# NextEra Energy Transmission West and Pacific Gas and Electric Company Estrella Substation and Paso Robles Reinforcement Project Proponent's Environmental Assessment (A.17-01-023)

## Response to Deficiency List No. 2

**PEA Figure 2-8a. 70 kV Substation General Arrangement**

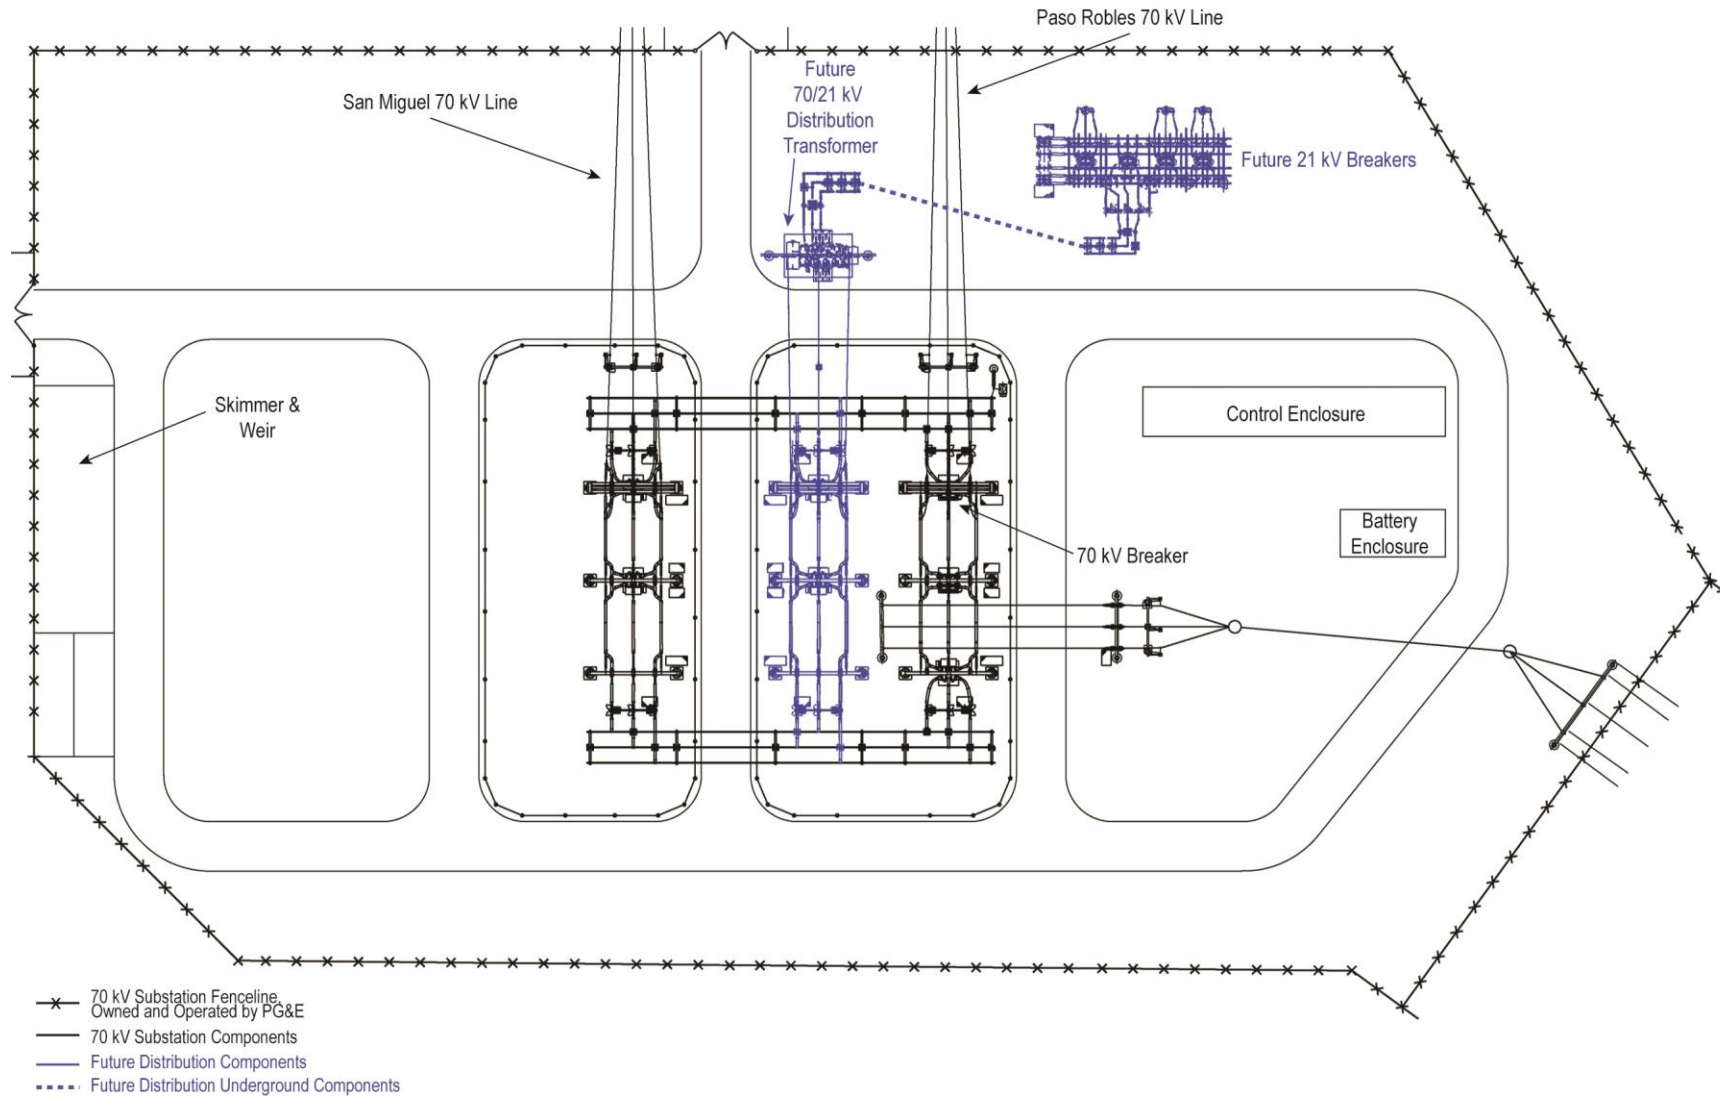
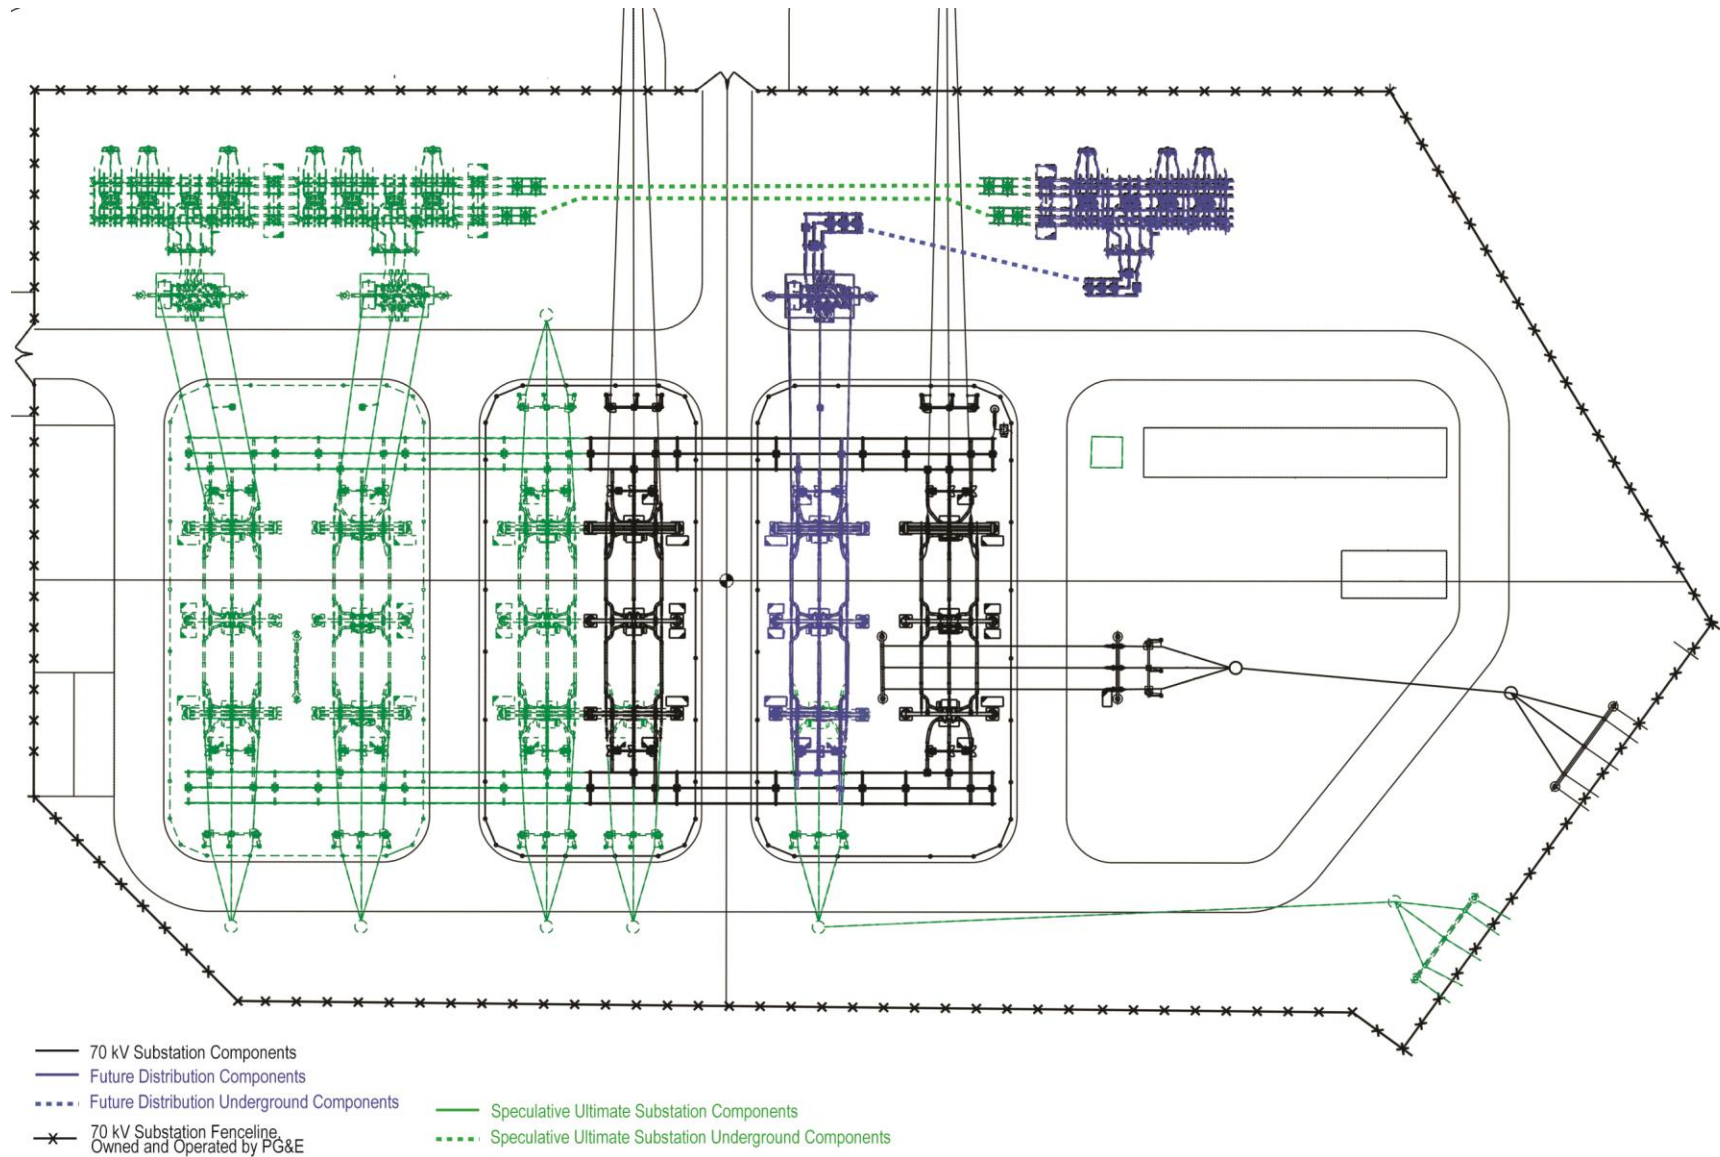
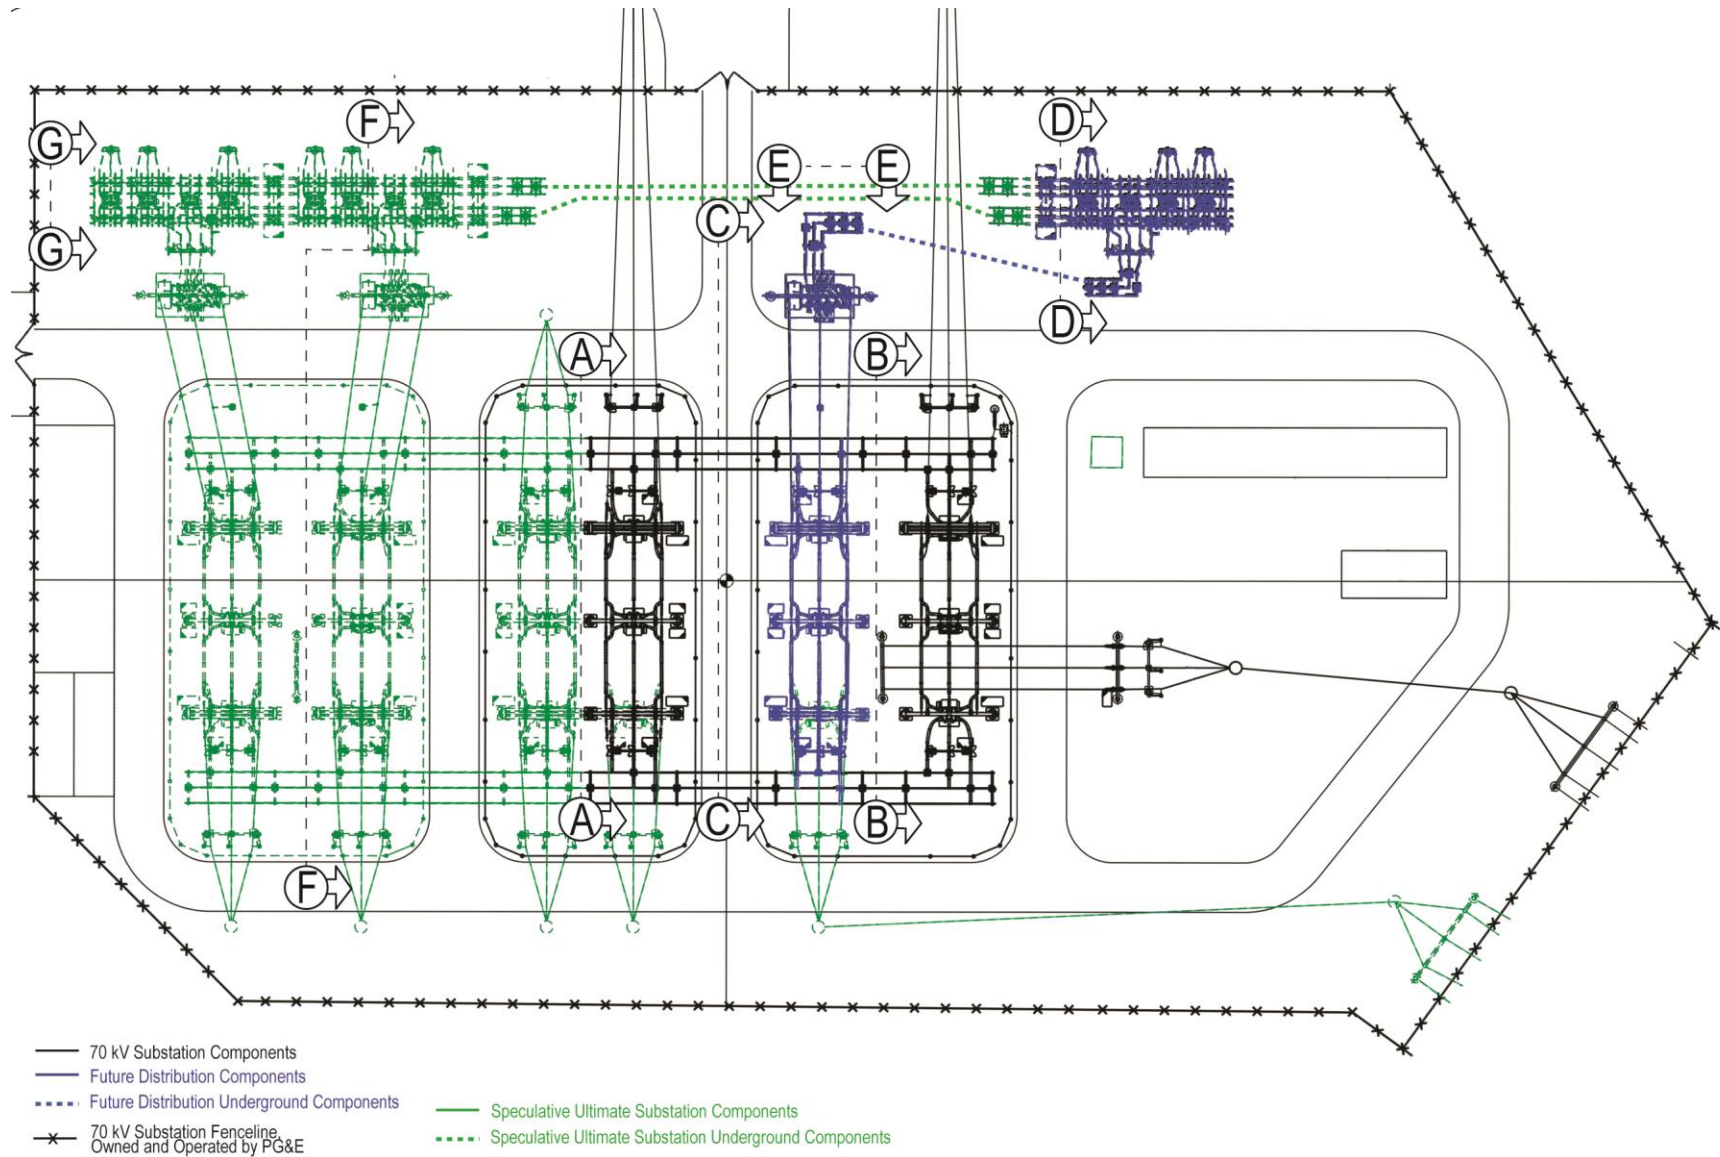
*Provide an updated version of Figure 2-8 that shows the full substation build-out. Estimate where facilities would likely be located. Use a color or other means to indicate future/estimated build-out. Label the added full-build-out facilities (i.e., future 230/70-kV transformer, three future 70/21 kV transformers and associated 70-kV breakers, 21-kV breakers, and switches). Identify the future 230-kV transmission tie-line alignments.*

As described in the response to Deficiency 2-18 above, since the design of the ultimate build-out is not yet known and is not planned, designed, or reasonably foreseeable, its impacts are speculative and not analyzed in the PEA. The 70 kV substation and future distribution facilities will be owned and operated by PG&E.

PEA Figure 2-8 was updated in the Revised PEA to show the 70 kV Substation with the planned future distribution facilities, including one transformer and three feeders. In response to Deficiency 2-21, the applicants have further updated PEA Figure 2-8 to include a speculative view of an ultimate build-out including three future 70/21 kV transformers and associated 70 kV breakers, 21 kV breakers, and switches (Figure 2-8b below). Since the ultimate build-out shown on Figure 2-8 is intended to show only distribution facilities and does not include the necessary 230 kV transmission tie-line, the future 230 kV tie-line alignment is not shown. Current technology is assumed for purposes of the illustration.

**PEA Figure 2-10. 70 kV Substation Profile View**

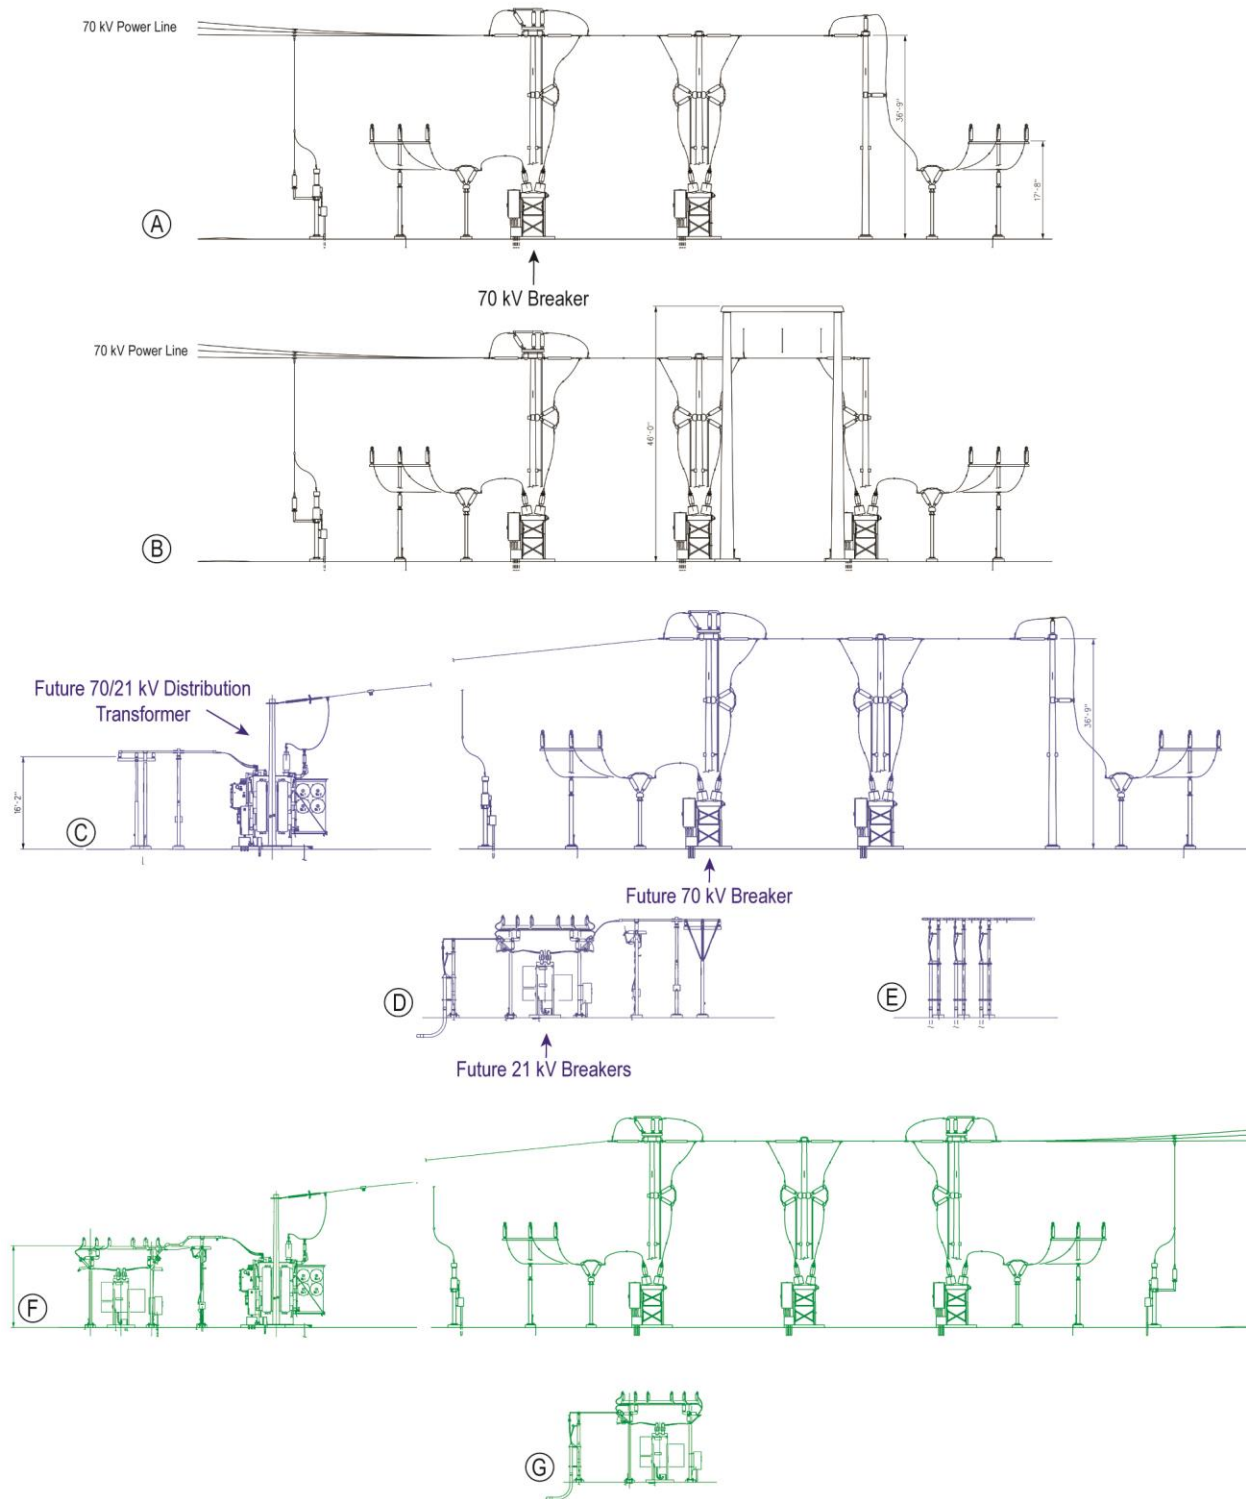
*Update Figures 2-9 and 2-10 with all future 70-kV and distribution facilities. Use a color or other means to indicate future/estimated build out.*

As described in the response to Deficiency 2-18, since the design of the ultimate build-out is not yet known, and is not planned, designed, or reasonably foreseeable, its impacts are not analyzed in the PEA.

PEA Figure 2-9 is the profile view of the initial build-out of the 70 kV substation. Figure 2-10 was updated in the Revised PEA to show the profile view of the 70 kV substation with the planned future distribution facilities. PEA Figures 2-9 and 2-10 have been updated again to include a speculative view of an ultimate arrangement including three future 70/21 kV transformers and associated 70 kV breakers, 21 kV breakers, and switches (Figures 2-9 and 2-10). Current technology is assumed for purposes of the illustration.

**Exhibit 3.4-5. Suitable Vernal Pool Fairy Shrimp Upland Habitat Map**

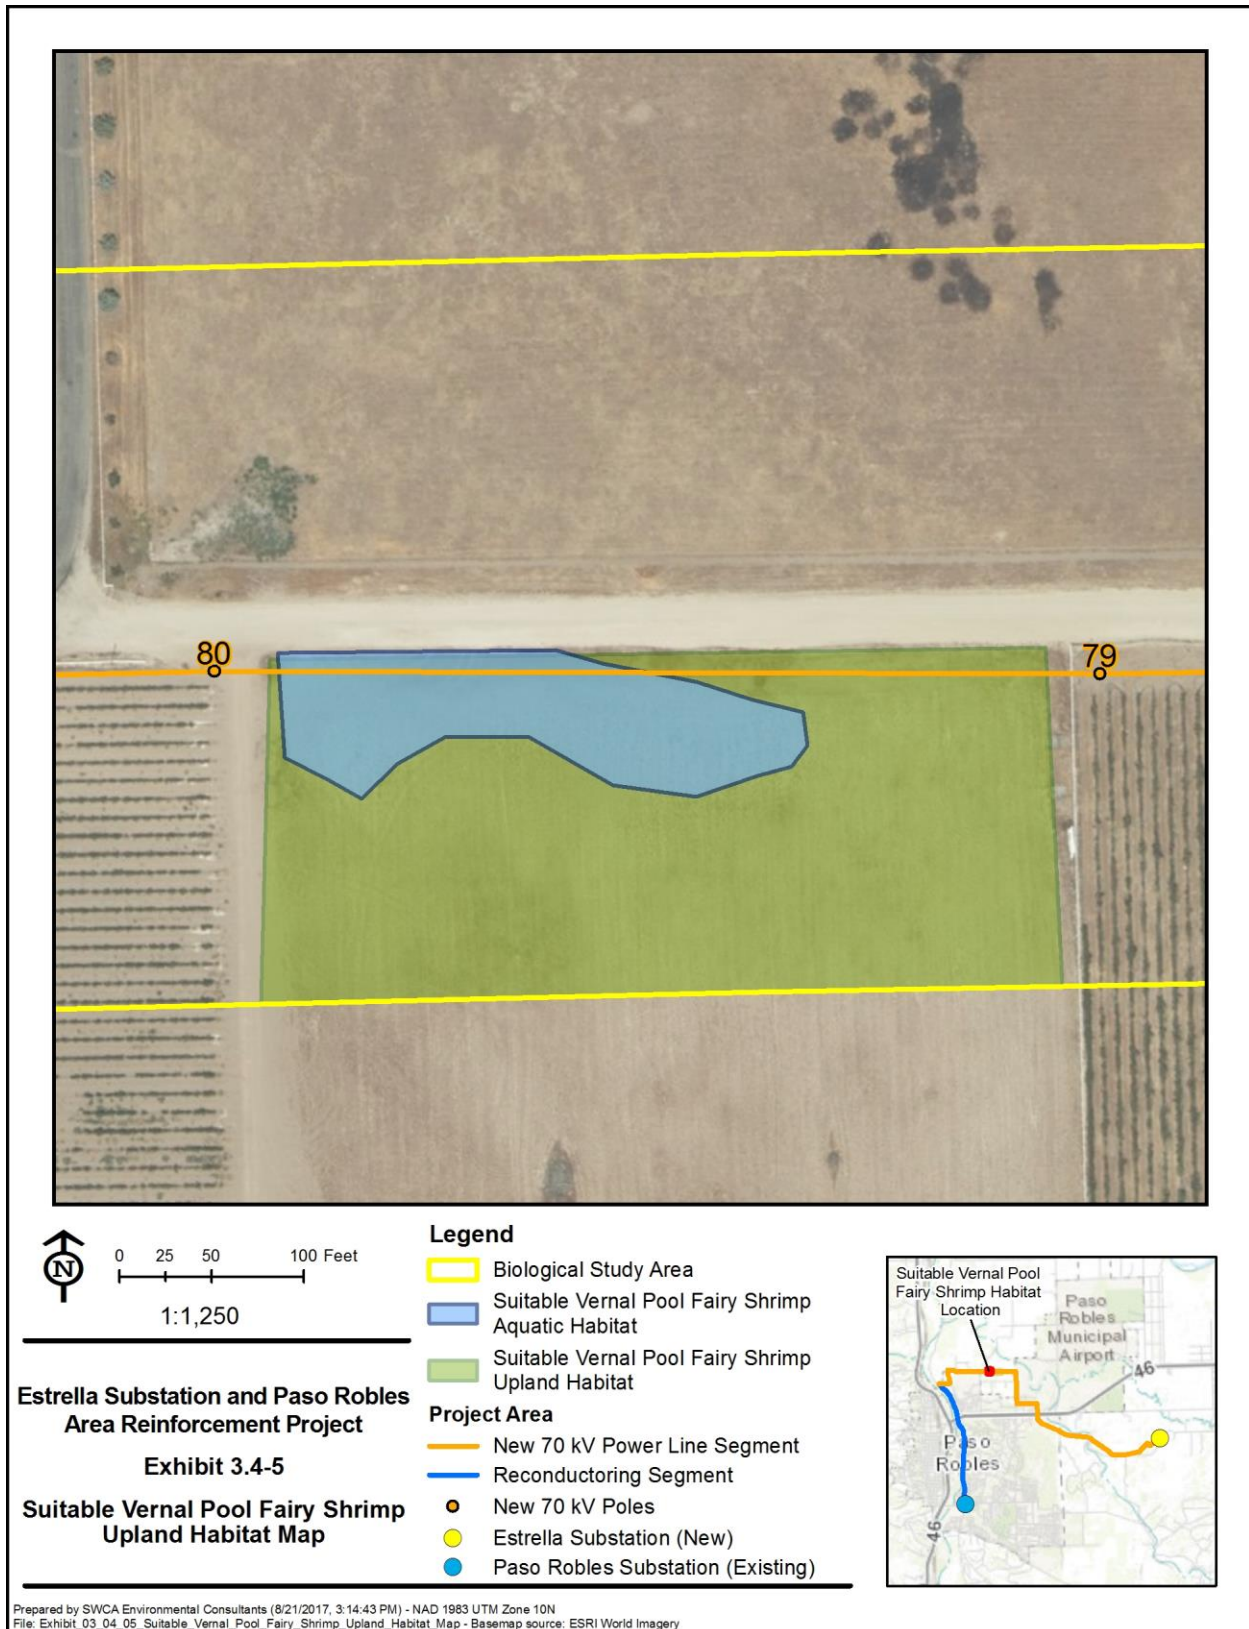
*Please indicate on a GIS-based figure where upland vernal pool fairy shrimp habitat is located in relation to the mapped seasonal wetlands described on p. 3.4-33*

As noted in the response to Deficiency 3.4-1 above, one wetland was determined to provide potential habitat for vernal pool fairy shrimp. Upland areas adjacent to this habitat can indirectly affect the wetland habitat through a loss of watershed, human intrusion, introduced species, or pollution. In cases when the reaches of these effects cannot be determined, all habitat within 250 feet could be considered indirectly affected. After conducting the wetland delineation, PG&E designed the new 70 kV power line spanning this seasonal wetland to ensure that the location of the two poles that would be placed nearest to this feature will not indirectly affect it. The wetland is bound by an adjacent road to the north, and the properties on both the east and west side of the wetland have been graded and leveled for vineyard operations, altering their hydrology. PG&E has engineered the poles east and west of the wetland to be placed along vineyard roads to reduce the project's indirect and direct impacts to the hydrology of the seasonal wetland. Because the existing hydrological impacts and alteration of the roads have already occurred, PG&E will not cause further degradation of the hydrology of these altered areas. The location of this upland habitat and pole placements is depicted on Exhibit 3.4-5, Suitable Vernal Pool Fairy Shrimp Upland Habitat Map.
